Request for Authorization to Use a TRIGA Element Positioning Device in the TRIGA Basket in the Model No. NAC-LWT Package, U.S. Nuclear Regulatory Commission (NRC) Certificate of Compliance (CoC) No. 9225, when Shipping General Atomic TRIGA Fuel

Docket 71-9225

TAC Number: L24417

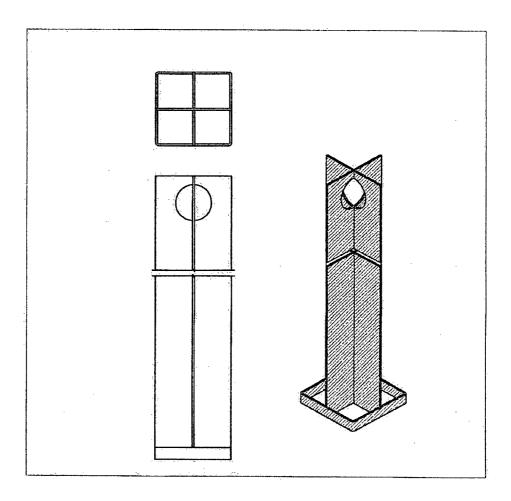
NAC International (NAC) hereby requests a letter authorization to permit the optional use of a TRIGA fuel element positioning device (fuel cell divider) in the fuel cells of TRIGA baskets when shipping General Atomic (GA) TRIGA fuel elements in the NAC-LWT cask. The divider is dunnage that will remain in the fuel cell during transport. The letter authorization for the optional use of these cell dividers is requested to cover 12 months from the date of the authorization to support the upcoming GA TRIGA shipping campaign.

The need has been identified for the use of an axial positioning device in the TRIGA fuel basket to facilitate loading and positioning of some of the TRIGA and dummy fuel elements within a fuel cell for the GA TRIGA shipments. NAC has developed a conceptual design for a 304 stainless steel axial cell divider that fits inside the fuel cell of

the TRIGA baskets. The height of the fuel cell divider is approximately 26 inches with the maximum height not to exceed the basket cell height.

A fuel cell divider may be placed into the basket opening during loading and may remain in the basket during transport. This divider will ensure the ability to load 4 rods per basket fuel cell opening.

To evaluate the effect of the fuel cell divider, NAC re-evaluated the maximum reactivity case with a cell divider model inserted. Results of this analysis are shown on the next page and confirm the assumption that the addition of the fuel cell divider will reduce

system reactivity. Analysis presented in the NAC-LWT Safety Analysis Report demonstrated that the system is under-moderated with maximum reactivity achieved by maximum fuel rod separation within the basket cell. The effect of the fuel cell divider is large for the wet basket case where moderator displacement significantly affects the thermalization of the fission neutrons. The effect is smaller but still noticeable in the dry case where higher energy neutrons still interact with the steel plate.
